PCN-259985

Product Change Notice

Alternative PCB supplier for AS33 and QS33 Series for assurance of supply.

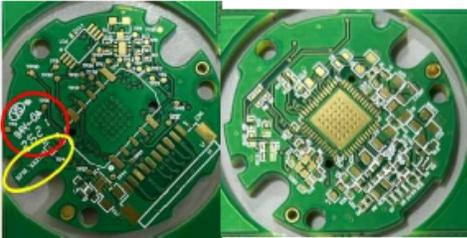
Before Change	After Change
PCB Supplier A	PCB Supplier B
<p>Silkscreen 1</p> 	
<p>Silkscreen 2 (date code 3821 onwards)</p> 	
X6 PCB supplier logo (in RED)	X6 PCB supplier logo (in RED)
